UNITED STATES PATENT AND TRADEMARK OFFICE

Office Action Summary	Application No. 10/765,391	Applicant(s) DI BITONTO ET AL.
	Examiner PHONG H. NGUYEN	Art Unit 3724

DETAILED ACTION

FIG. 5

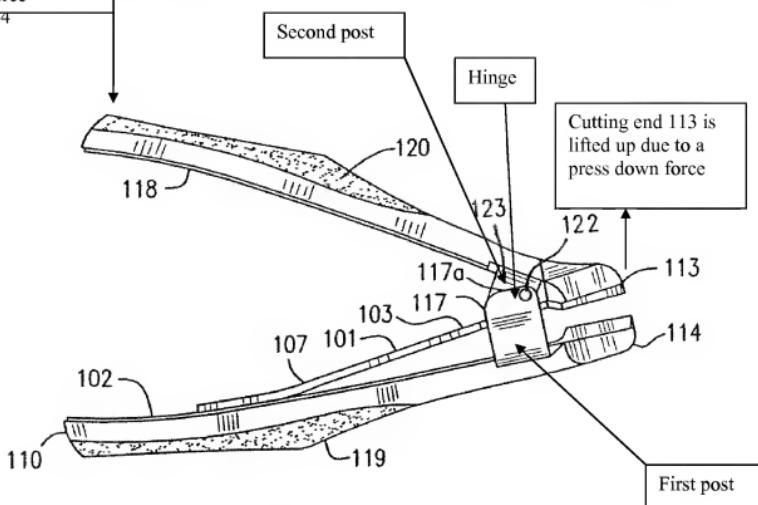
1. The disclosure is objected to under 37 CFR 1.71, as failing to describe how the claimed nail clipper functions. It is to be noted that for the purpose of this office action, the Examiner uses the latest Amendments to the Specification and the Drawings filed on 12/15/2008 to explain his position.

It is to be noted that the last sentence in the Amendments to the Specification states "a second post 122 is connected to the post 117 by a hinge 123" while the Amendments the Drawings shows the second post being designated by numeral 123 and the hinge being designated by numeral 122. For the discussion, the Examiner assumes that numeral 123 is the second post and numeral 122 is the hinge.

According the principle of leverage, the first post 117 acts as a fulcrum and the lever 118 pivots about the hinge 122. When the lever 118 is pressed down, the cutting end 113 is lifted up according the principle of leverage. This is not the intended use of the nail clipper which the press down force is supposed to bring the cutting ends (113, 114) close together to cut a nail.

Regarding claims 1, 22 and 23, it is unclear how the claimed lever, first post, second post and hinge are adapted to cause the movement of the cutting edges between a cutting position and a non-cutting position. See explanation above.

Applicant is required to submit an amendment which clarifies the disclosure so that the examiner may make a proper comparison of the invention with the prior art. Applicant should be careful not to introduce any new matter into the disclosure (i.e., matter which is not supported by the disclosure as originally filed).
